# Recall Bulletin

## NONCOMPLIANCE RECALL

**SUBJECT:** Daytime Running Lights Disabled

**MODELS:** 2013 Cadillac ATS

4001402

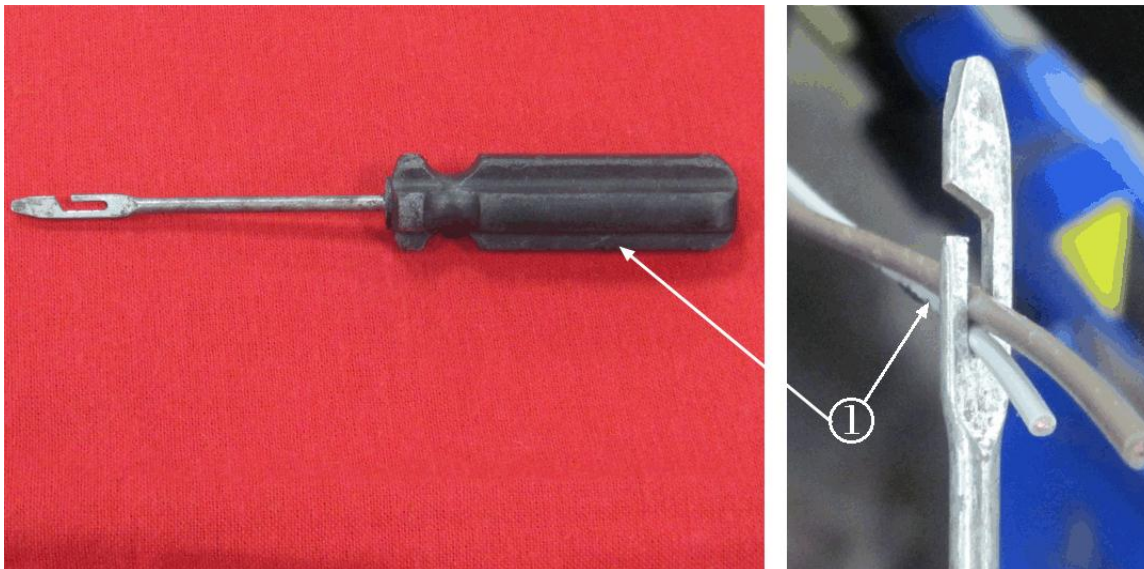
4. Locate the right body harness grommet (1). The grommet is located in the engine compartment on the passenger side of the vehicle. The grommet is below the plenum.
5. Locate the two holes in the right side body harness grommet.
6. Insert an awl, metal rod or equivalent (3) into the inside grommet hole (2).
7. Push the awl, metal rod or equivalent (3) through the inside hole until an opening is created. The opening in the grommet must allow access from the engine compartment into the inside of the vehicle.

4001407

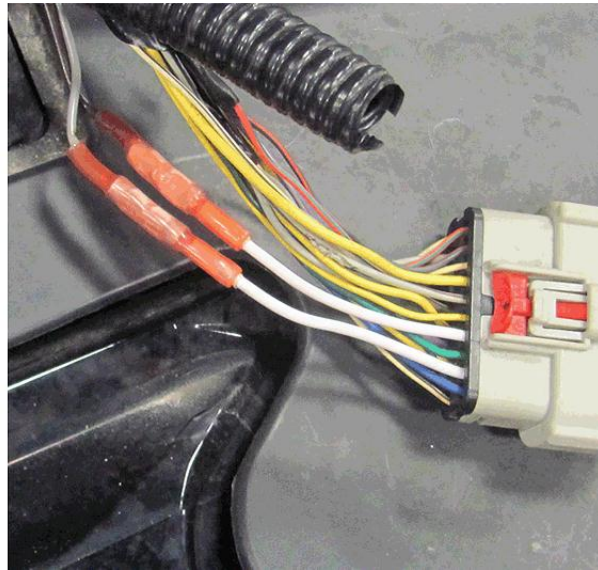
8. From inside the vehicle, use a tire plug installation tool, metal rod or equivalent (1) to route two 0.5 mm wires (brown and gray) through the grommet hole into the engine compartment.
9. Route the two 0.5 mm wires to the right side X 126 body harness to forward lamp harness connector. Route the 0.5 wires along the side of the body harness.

**X 126 body harness to forward lamp harness connector shown.**

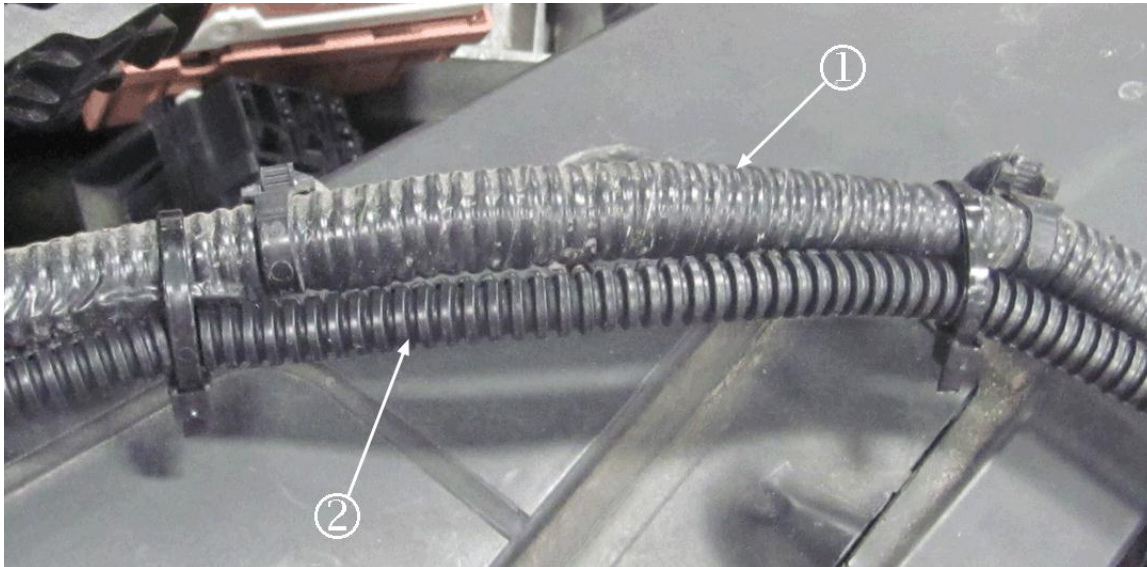
11. Disassemble the X 126 body harness to forward lamp harness connector.
12. Install the brown wire (circuit 4357) with the terminal lead into PIN 7 of the X 126 body harness to forward lamp harness connector. Refer to *Connector End Views: X 126 Body Harness to Forward Lamp Harness* in SI.

13. Install the gray wire (circuit 4356) with the terminal lead into PIN 9 of the X 126 body harness to forward lamp harness connector. Refer to *Connector End Views: X 126 Body Harness to Forward Lamp Harness* in SI.
